CONSTRUCTION STANDARD DRAWINGS

MEMORANDUM

To: All Users of the Roadway Construction Standard Drawings	**Date:** 20 Oct 04
From: Mary Viparina Assistant State Engineer Roadway Engineering Group	**Subject:** C-Standards Update

APPROVED FOR DESIGN	STATE OF ARIZONA DEPARTMENT OF TRANSPORTATION ROADWAY STANDARD DRAWINGS	REV.
APPROVED FOR DISTRIBUTION	GUARDRAIL MEASUREMENT LIMITS	DRAWING NO. 1 C-10.00

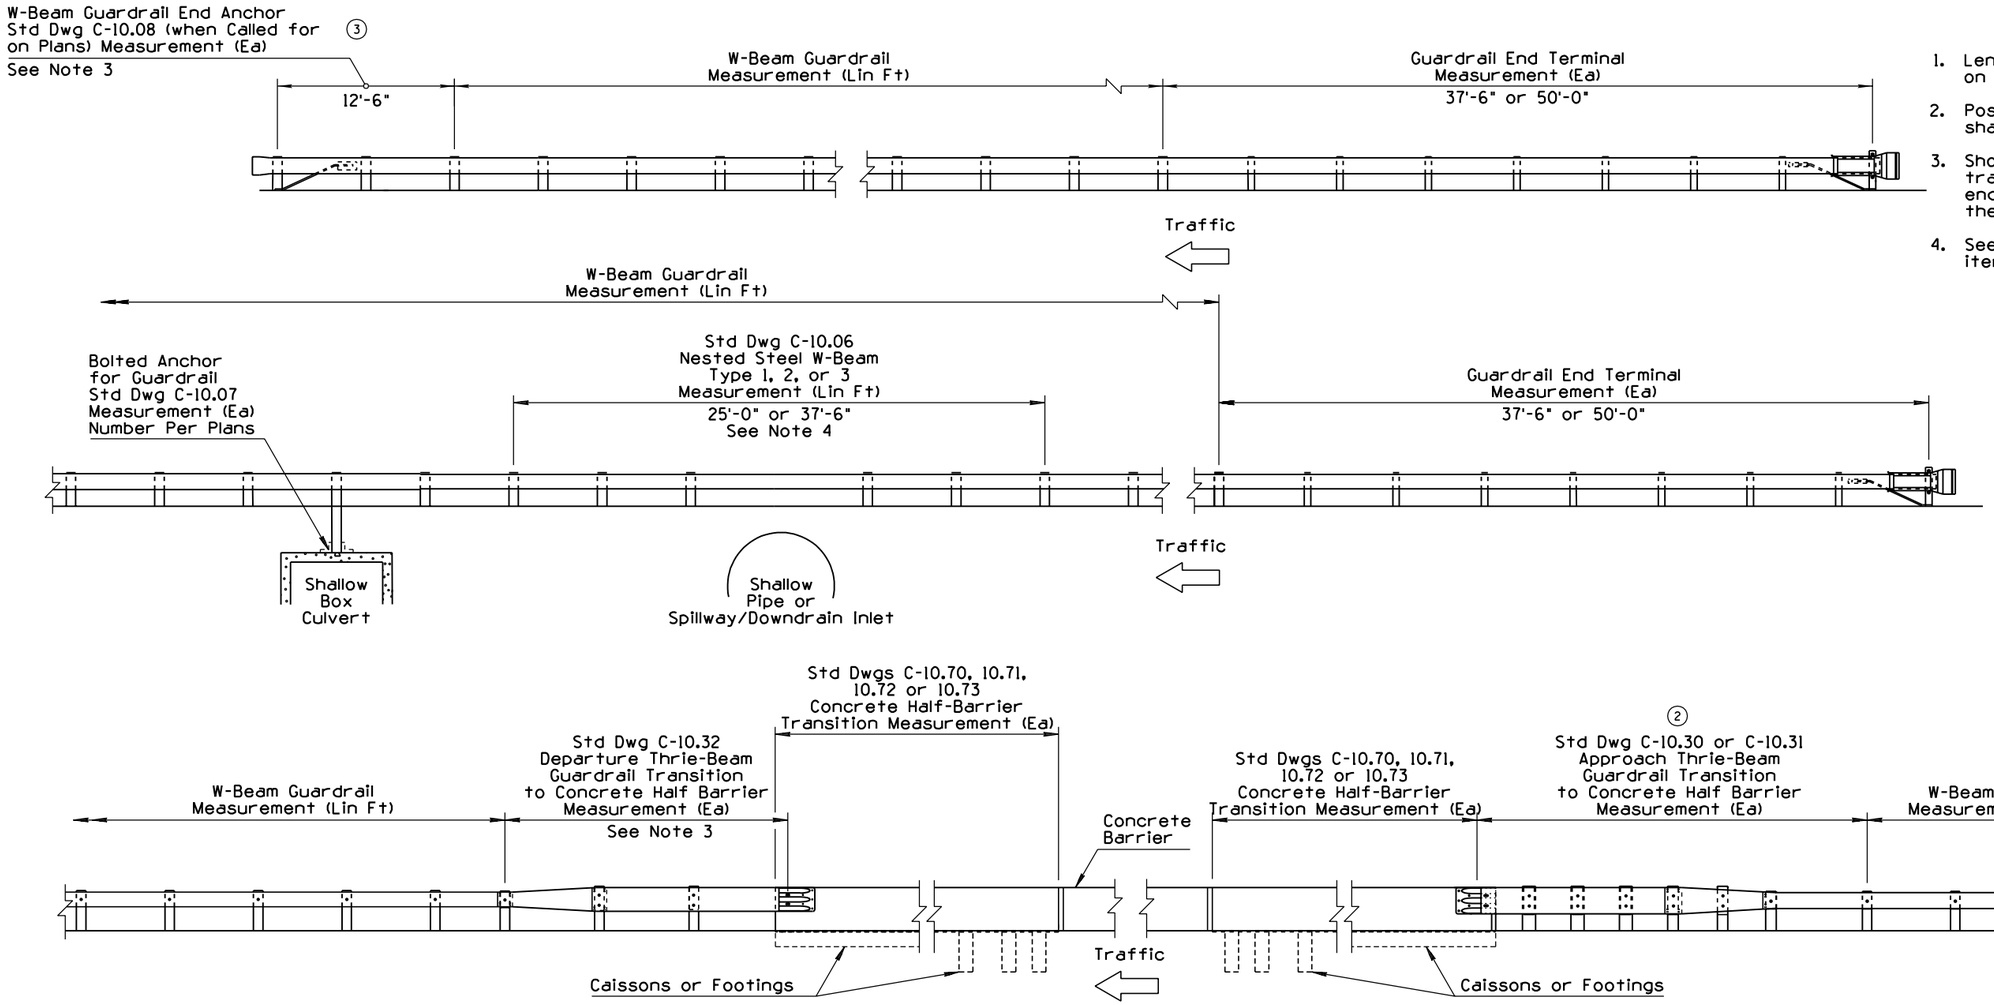
NO	DESCRIPTION OF REVISIONS	MADE BY	DATE
1	RENAMED STANDARD DRAWING FROM C-10.03 TO C-10.00	RLF	9/04
2	REVISED BARRIER TRANSITION	RLF	9/04
3	REVISED NAMING CONVENTION	RLF	9/04
4

APPROVED FOR DESIGN	STATE OF ARIZONA DEPARTMENT OF TRANSPORTATION ROADWAY STANDARD DRAWINGS	REV.
		9/04
APPROVED FOR DISTRIBUTION	W-BEAM GUARDRAIL 1 NESTED TYPES 1 AND 2	DRAWING NO. 1 C-10.06 Sheet 1 of 2

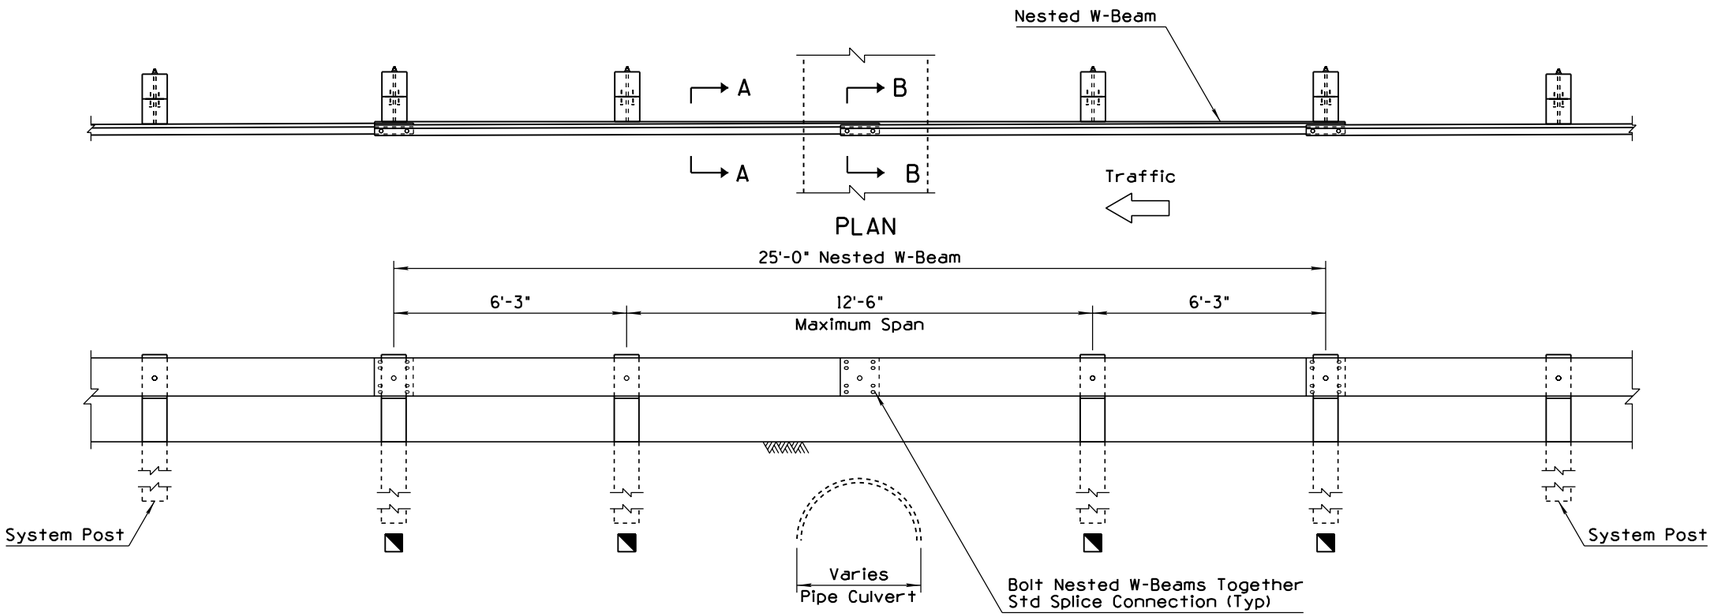
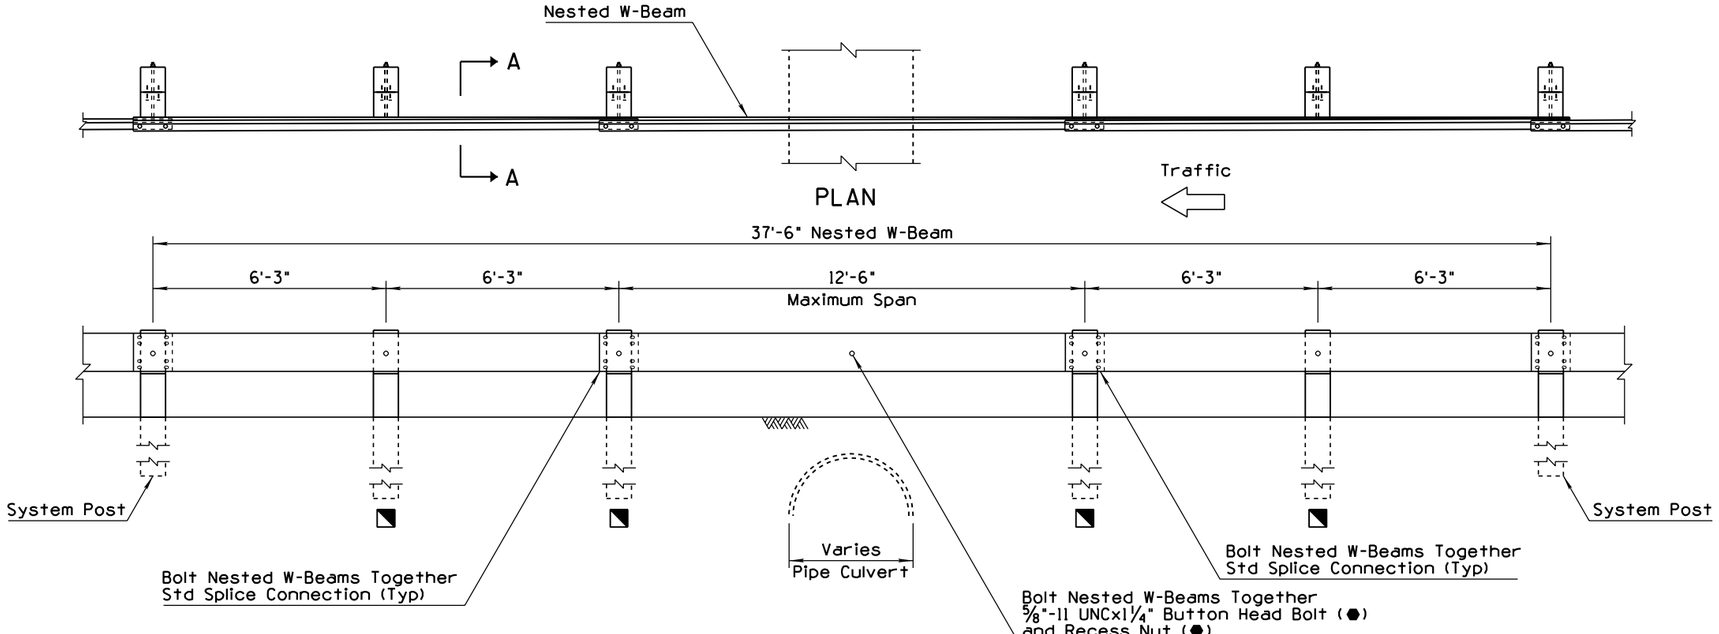
NO	DESCRIPTION OF REVISIONS	MADE BY	DATE
1	RENAMED STD DWG FROM C-10.28, 1 OF 2 & REVISED TITLE	RLF	9/04
2	REVISED DESIGNATION	RLF	9/04
3	REVISED GENERAL NOTES 2 & 3	RLF	9/04
4	REVISED SECTION VIEW	RLF	9/04

APPROVED FOR DESIGN	STATE OF ARIZONA DEPARTMENT OF TRANSPORTATION ROADWAY STANDARD DRAWINGS	REV. 4/05
APPROVED FOR DISTRIBUTION	GUARDRAIL TRANSITION, THRIE BEAM TO CONCRETE HALF BARRIER 32" TYPE 'F'	DRAWING NO. 3 C-10.30 Sheet 1 of 2

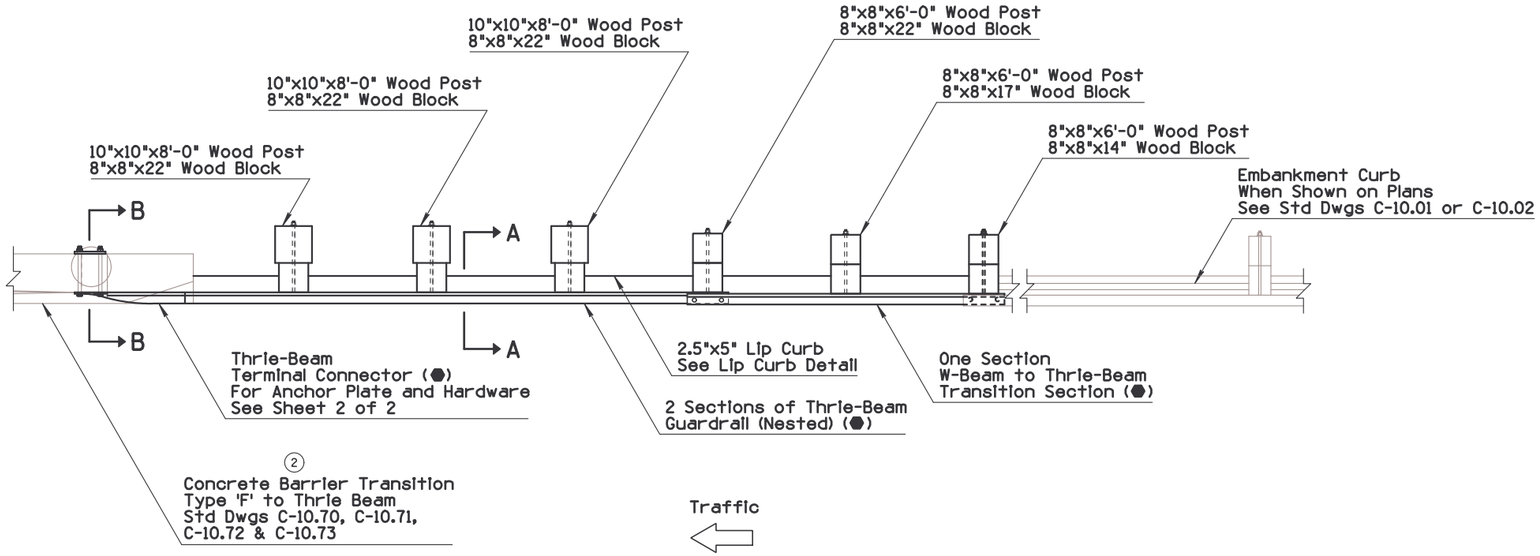
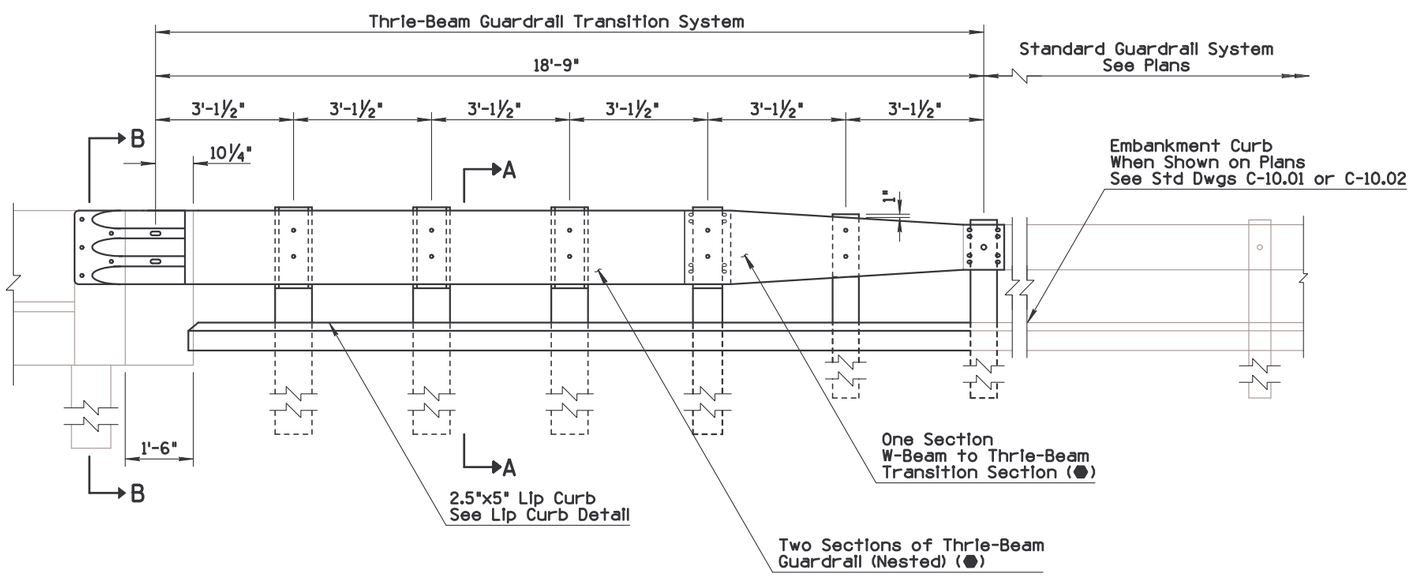
NO	DESCRIPTION OF REVISIONS	MADE BY	DATE
1	REMOVED (A325) REQUIREMENT	RLF	12/04
2	REVISED BARRIER TRANSITION CALLOUT	RLF	4/05
3	REISSUED AS STANDARD DRAWING C-10.30, SHEET 1 OF 2	RLF	4/05
4

APPROVED FOR DESIGN	STATE OF ARIZONA DEPARTMENT OF TRANSPORTATION ROADWAY STANDARD DRAWINGS	REV.
APPROVED FOR DISTRIBUTION	GUARDRAIL TRANSITION, THRIE BEAM TO CONCRETE HALF BARRIER 32" TYPE 'F', (APPROACH), PCCP	9/04 DRAWING NO. C-10.31

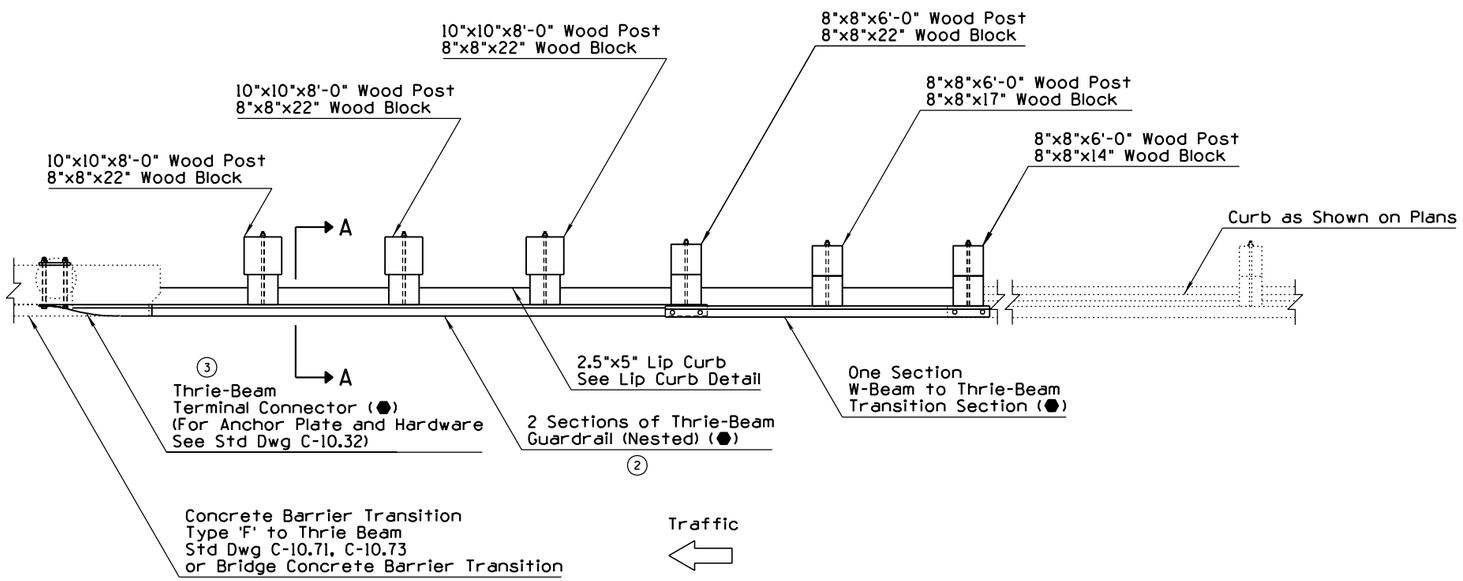
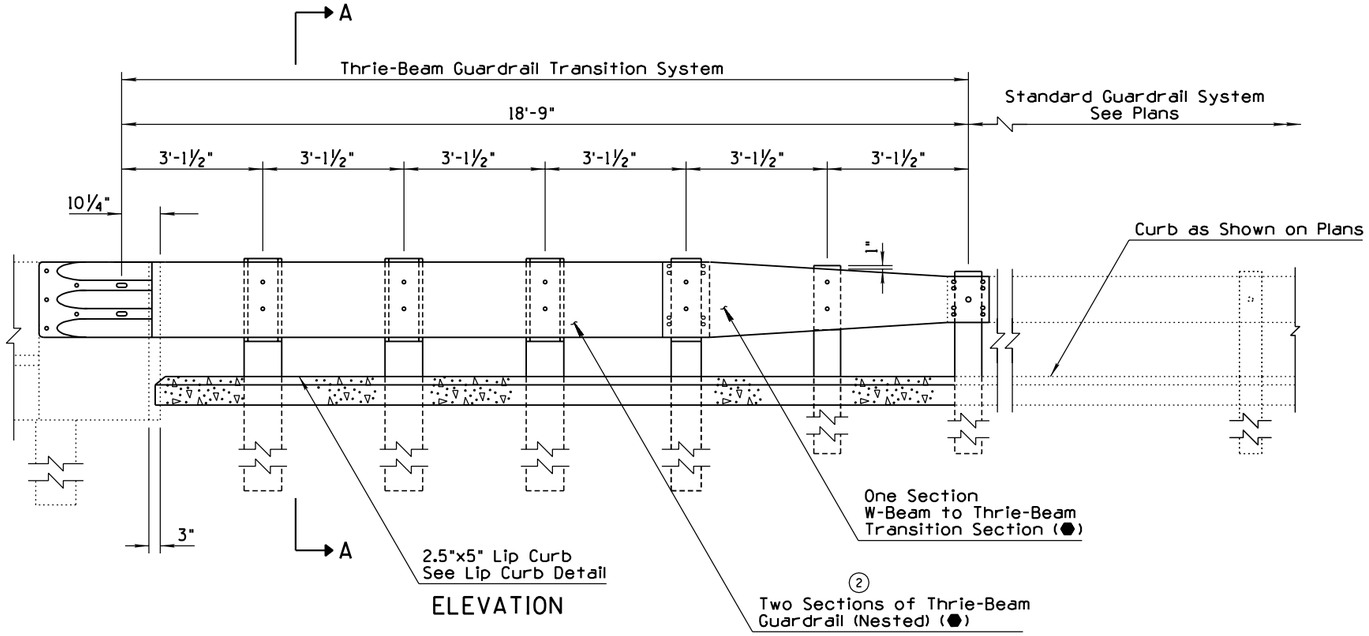
NO	DESCRIPTION OF REVISIONS	MADE BY	DATE
1	REVISED POST SIZES AND SPACING	RLF	9/04
2	ADDED NESTED THRIE BEAM REQUIREMENT	RLF	9/04
3	ADDED ANCHOR PLATE REFERENCE	RLF	9/04
4	ADDED (A325) REQUIREMENT	RLF	9/04

APPROVED FOR DESIGN	STATE OF ARIZONA DEPARTMENT OF TRANSPORTATION ROADWAY STANDARD DRAWINGS	REV.
Mary Viparina		9/04
APPROVED FOR DISTRIBUTION	CONCRETE MEDIAN BARRIER ① 42" TYPE 'F' CAST-IN-PLACE	DRAWING NO. ① C-10.41

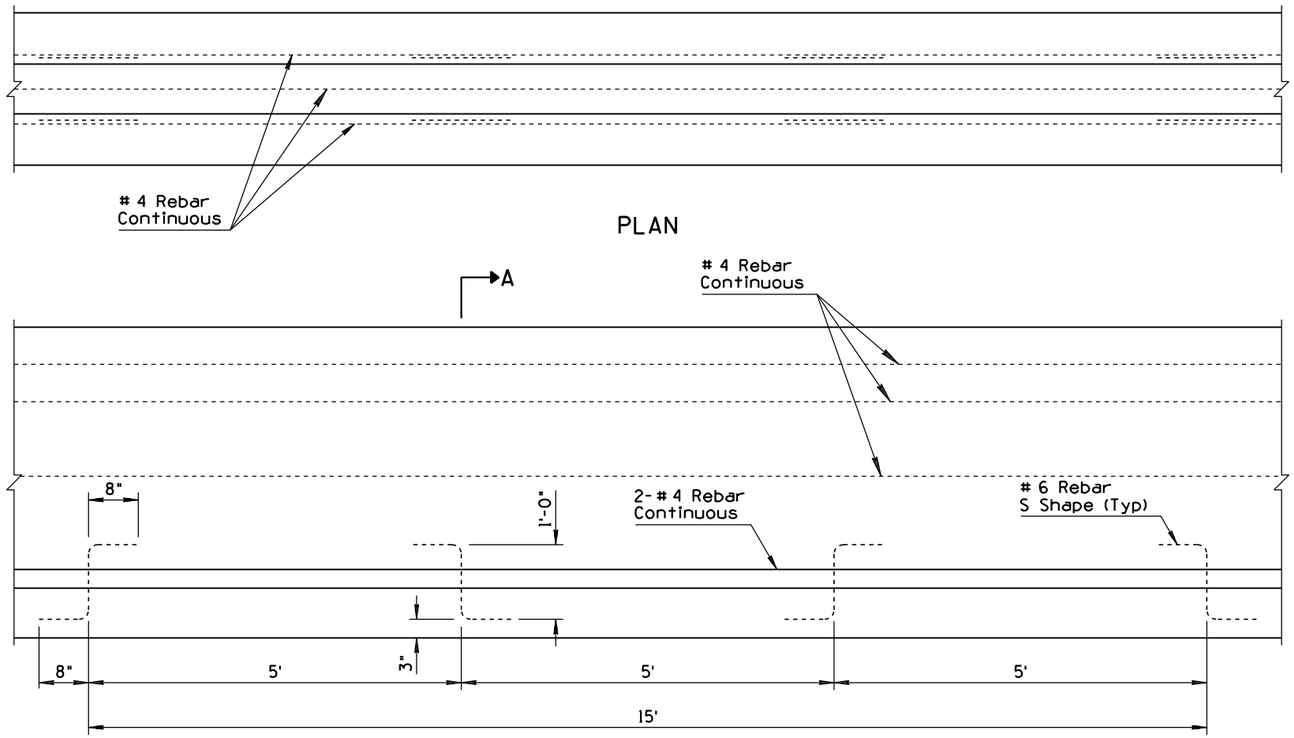
NO	DESCRIPTION OF REVISIONS	MADE BY	DATE
1	RENAMED STD DWG FROM C-10.67 & REVISED TITLE	RLF	9/04
2	REVISED GENERAL NOTE 3	RLF	9/04
3	RELOCATED # 4 REBARS	RLF	9/04
4

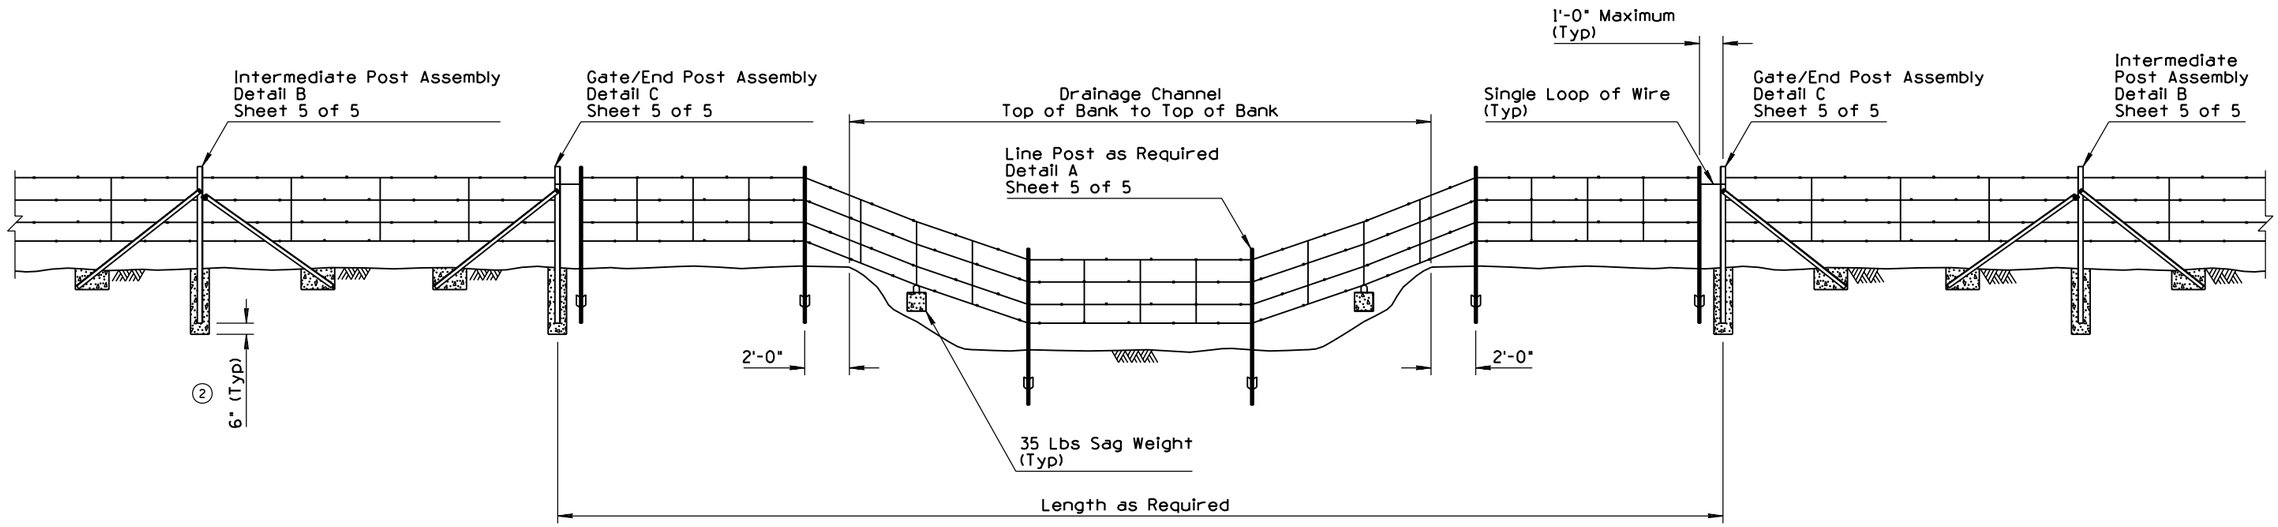
NO	DESCRIPTION OF REVISIONS	MADE BY	DATE
1	REISSUE STD	PNB	7/94
2	ADDED DIMENSION	RLF	9/04
3			
4
